ORDINANCE NO. 1885

**AN ORDINANCE TO AMEND LANE PARKE DEVELOPMENT
PLAN PREVIOUSLY APPROVED BY ORDINANCE 1871**

MEMO

RE: Amendment to Lane Parke PUD

2 STORY BUILDINGS

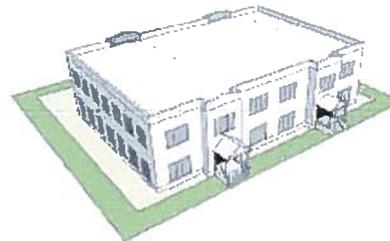
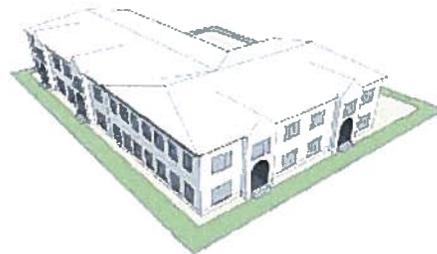
- For buildings fronting on Park Lane Court South and/or Main Street, ground floor elevation is required to be 1.5' to 4' above grade at front building line. ("Leasing" office in residential component excluded).

* For buildings fronting on Park Lane Court South and/or Main Street. ("Leasing" office in residential component excluded).
